| Title: Susitna-Watana Hydroelectric Project, FERC Project No. 14241-000 ; Review of Initial Study Reports | | SuWa 292 |

Subject: Susitna-Watana Hydropower Project, FERC Project No. 14241-000; Review of Initial Study Reports

Enclosure 3: Individual study requests for modification and new study

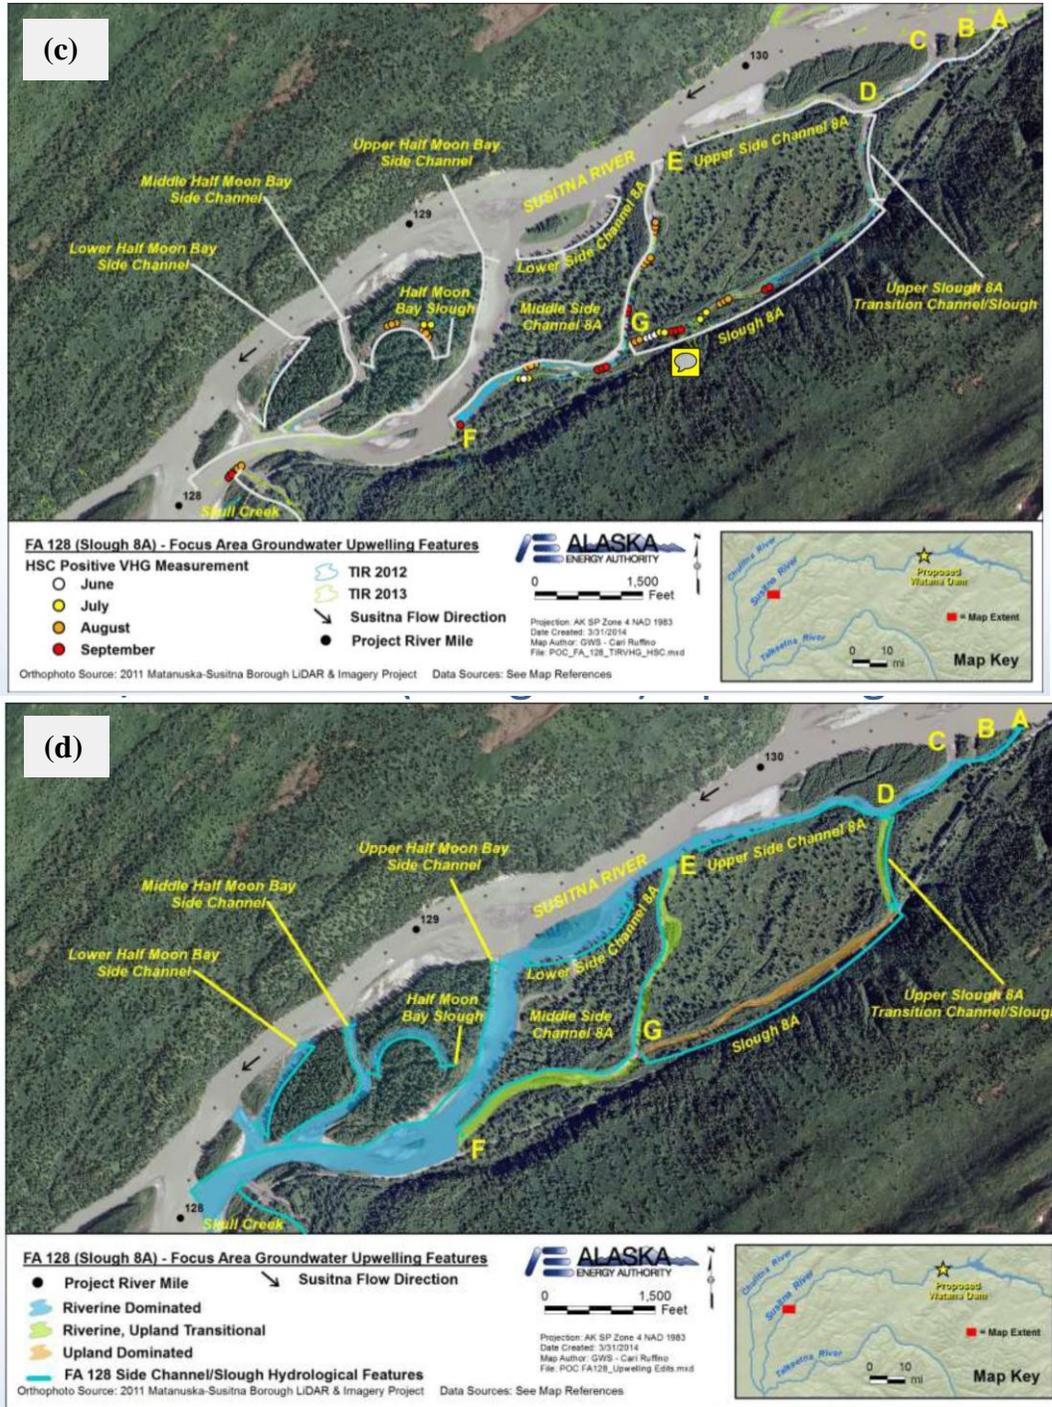
To illustrate this point, figures 1a-d (Section 5.0, this document) compare the locations of water quality sampling locations within FA-128, to areas of potential groundwater upwelling identified using both TIR data and streambed vertical hydraulic gradient measurements. Figure 1a is taken from the Baseline Water Quality ISR [URS and Tetra Tech, 2014]; Figure 1b is taken from the October 2012 TIR Mapbook [URS and Watershed Sciences Inc., 2013]; and Figures 1c-d are taken from a presentation [GW Scientific, 2014] delivered at the Riverine Modeling Proof of Concept meeting in April 2014. Comparison of the figures shows numerous zones of groundwater upwelling that do not coincide with water quality sampling locations.

The purpose of this comparison is not to argue that water quality samples are needed for each and every area of groundwater upwelling. Instead, it should be noted that the locations of water

quality sampling points probably do not completely bracket the range of conditions in the Middle River with respect to groundwater/surface-water interactions. For example, comparison of figures 1a and 1d shows that in FA-128, the water quality sampling locations (both point and transect) are located in zones delineated as “upland dominated” or “riverine dominated”. However, comparison of figures 1c and 1d shows that positive vertical hydraulic gradients were measured in numerous locations in zones delineated as “riverine, upland transitional”. These areas do not include water quality sampling locations. In order to address the Objective of this study element, it may be necessary to revisit sampling locations based on field data collected in 2013, to ensure that water quality sampling brackets the full range of groundwater-surface water conditions in the Focus Areas.

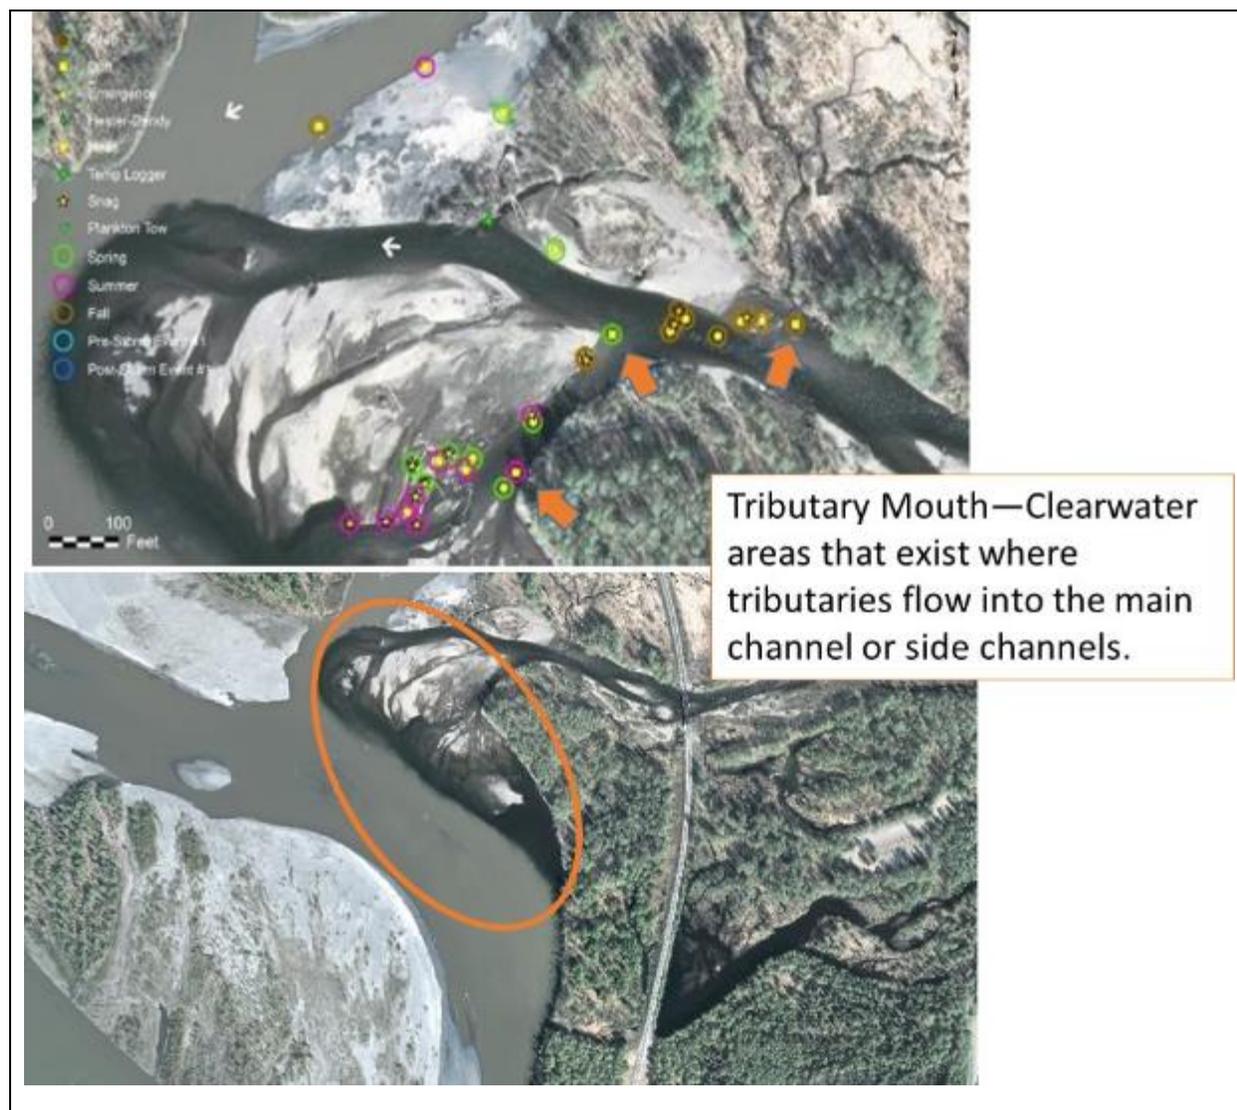
At all tributary mouth sampling units, sampling locations, for the five replicate samples, were collected in tributary deltas. None of the samples were collected within the portion of the main channel influenced by tributary flow (Figure A1 and A2). Tributary mouths are characterized by AEA as clearwater areas where tributaries flow into the mainstem. The macrohabitats can be further subdivided into tributary deltas and clearwater¹ plumes. Sampling units for the FDA Study 9.6 were further defined by FERC to include the tributary delta and 200 m downstream in the main-stem channel. Physical and water quality characteristics differ between the tributary delta (which is characterized by unstable substrate and shallow water depths) and the tributary-influenced main-stem (characterized by shallower slopes and greater depths). Juvenile salmon and resident fish may be more abundant within the main-stem influenced portion of this macrohabitat due to greater water depths, cover, and possibly higher productivity than other main-stem sites. Organic matter may deposit in these portions of the macrohabitat, and algal abundance may be higher due to reduced scour and more stable substrate. The exclusion of tributary-influenced mainstem habitats may lead to an underestimation of the importance of these habitats.

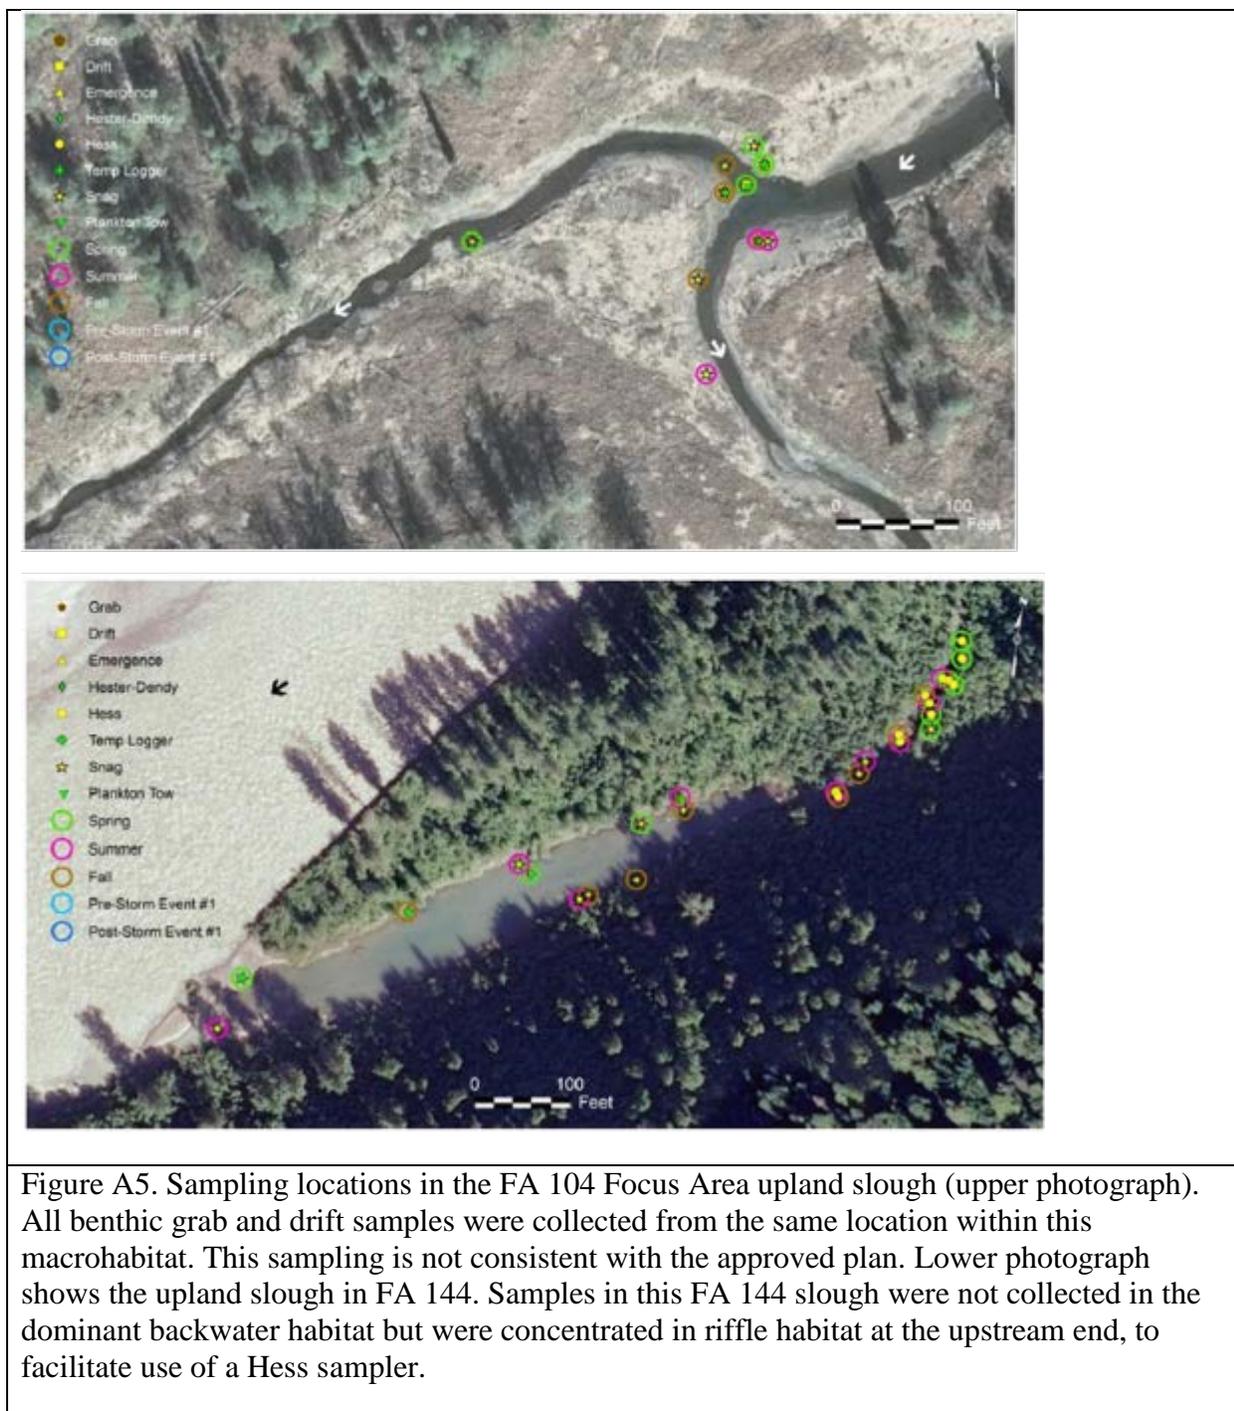
Benthic and algal samples were collected from an upland slough sampling unit in FA 104, however all sample replicates were collected from the same location (Figure A6). The IP states that samples will be distributed equally over the 200 m sampling unit. Therefore, sampling was not conducted according to the approved plan. Sampling locations within the FA 141 upland slough sampling unit appear to be inappropriately selected, based on limitations imposed by the Hess sampler. The SIR (Table 4.8-1) stated that both Hess and Ponar samplers were used to collect samples. No drift was sampled and it is not possible to determine which substrate was sampled to collect algae. The upland slough backwater is dominated by fine substrate and deep water. As such, sampling does not appear representative of this habitat and instead seems to have been conducted around the limitations imposed by the Hess sampler. In addition, replicate samples were all collected within close proximity to each other, particularly during spring and summer. Therefore, sampling was not conducted according to the study plan specifications, regarding representativeness. Benthic, algal, and drift samples were to be distributed evenly throughout the 200 m sampling unit and appropriate methods should be used for the substrate types and water velocity.

Sampling methods were also not consistent among macrohabitat types, as was required by FERC. For example, figure A6 shows sampling locations in an upland slough sampling unit where sampling was moved to the upper portion of the slough to accommodate a Hess sampler, even though a dredge or grab sampler was used in other upland sloughs.

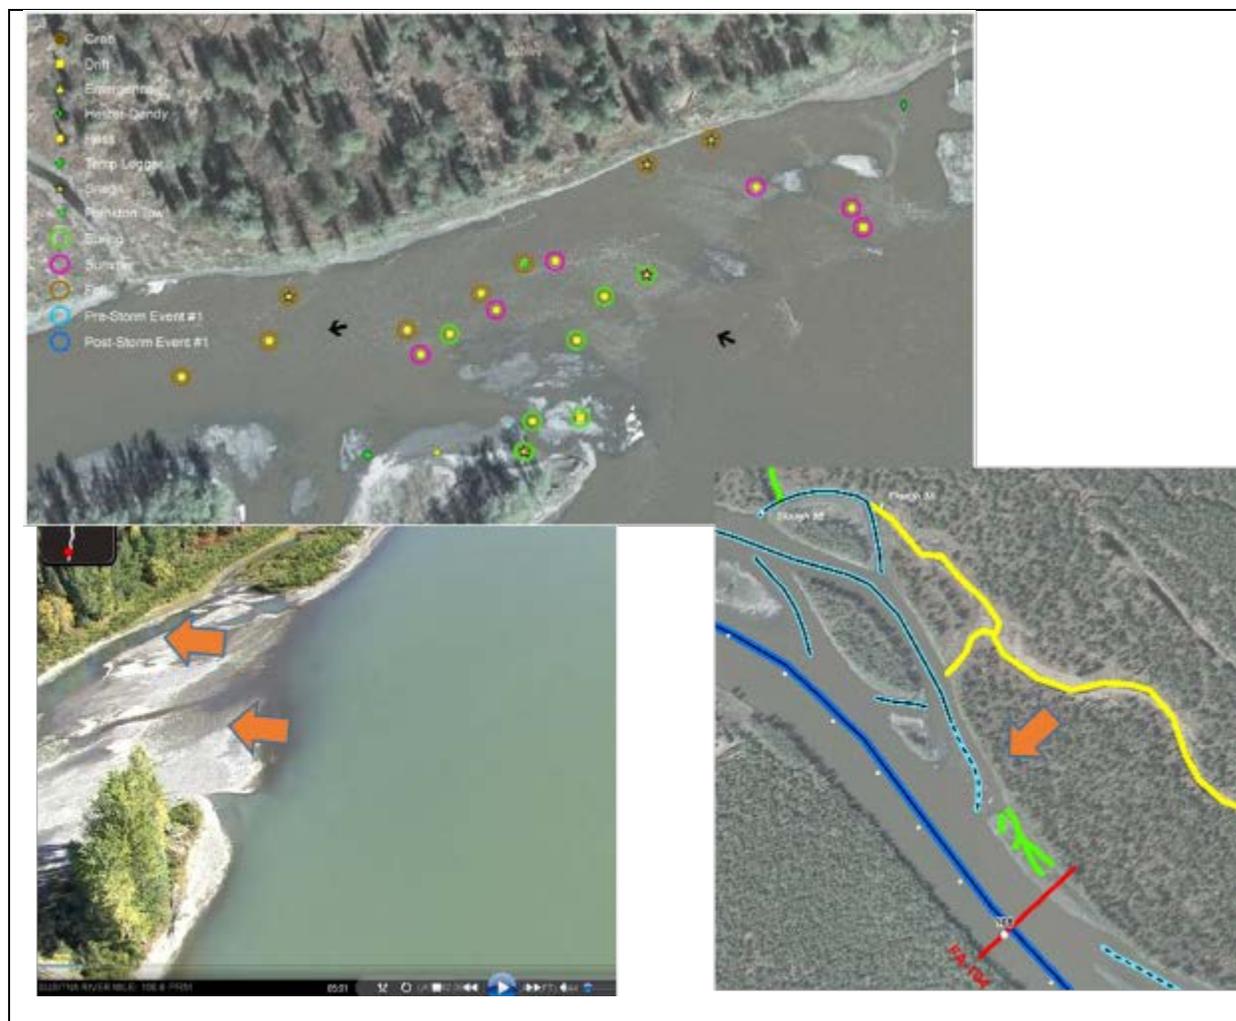
Figure A12 shows the channel site selected in FA 104 that is just downstream from an upland slough. The figure depicts the channel at flow levels used for habitat characterization (10,000 to 12,000 cfs) and it appears to clearly be within clearwater upland slough habitat. It appears that the only true side channel sampled was RP-81-4, but at this site all samples were collected from approximately the same location (AEA ISR Appendix B Figure B-4). Therefore, it is not clear to the whether macroinvertebrate or chlorophyll-a data were collected in such a way that side channels, though quite common in the Middle River, were adequately represented.

Benthic invertebrate, benthic organic matter, benthic algal sampling would benefit from adherence to AEA's IP. In future efforts, side channel sampling units should be selected such that they are representative, pursuant to the Project hierarchical habitat model. A minimum of 6 side channel sites should be sampled downstream from Devils Canyon. USFWS recommends including side channel habitat in FA 144 and FA 141, side channel habitat below Montana Creek (identified in Figure A13), side channel habitat in FA 138, side channel habitat in FA 138, side channel habitat in FA 115 or 114, and side channel habitat in FA 104.

Figure C3. Tributary 117.4 (arrows) as an example of habitat not classified by AEA as tributary mouth macrohabitat and clearwater plume; however, the habitat is clearly visible in the AEA’s 2012 imagery used for the remote line mapping as shown on inset.

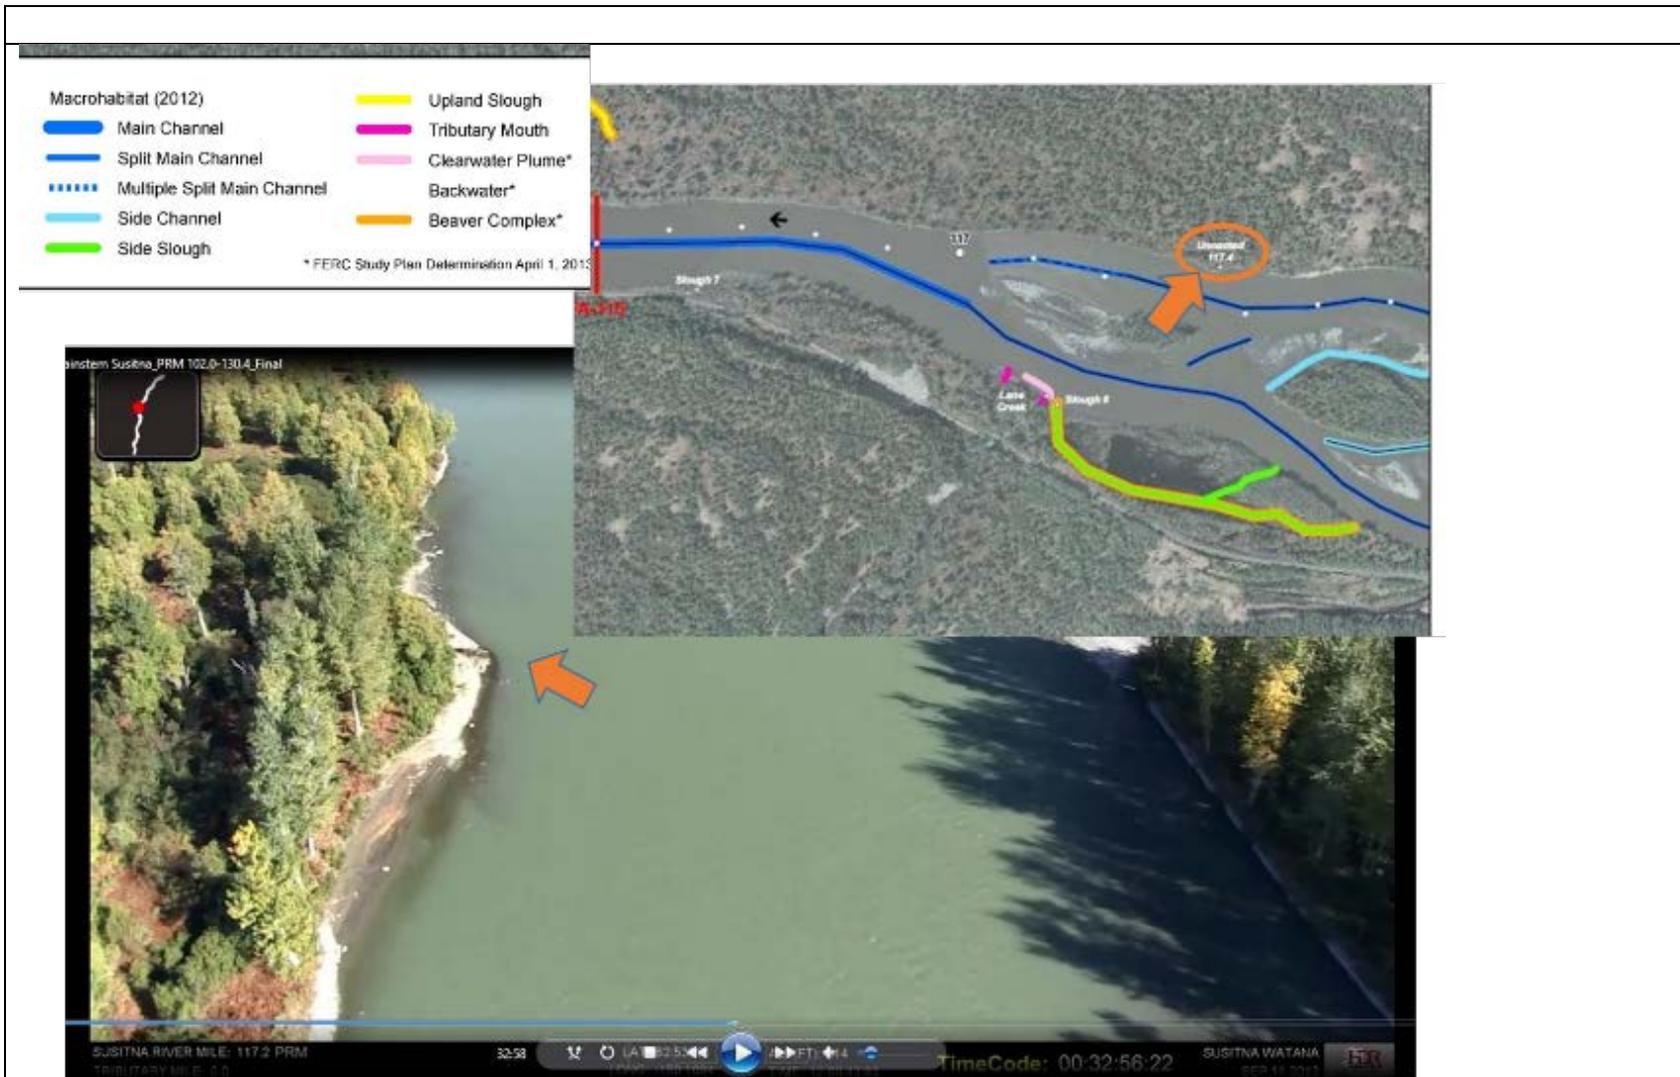
mouth at unnamed tributary 117.4 were not classified, even though a plume is clearly visible on the aerial imagery (Figure C3). McKenzie Creek and Little Portage Creek are not tributary mouths according to AEA (Map 47 of 55). However, they are both clearly tributaries and tributary plumes are visible on aerial imagery (Figure C4). The tributary at 124.4 (Curry) is identified as a tributary (SCR October 2015, Map 46 of 50) but the tributary clearwater plume is not classified, though clearly visible (Figure C5). If a tributary clearwater plume is not necessary for tributary mouth classification, then it is not clear why this is a tributary mouth while other tributary confluences were not classified. These same errors and inconsistencies continue throughout the river. Therefore it's not possible for the results of this classification, as shown in the SCR, to inform other studies on the number of tributary mouths available for sampling.
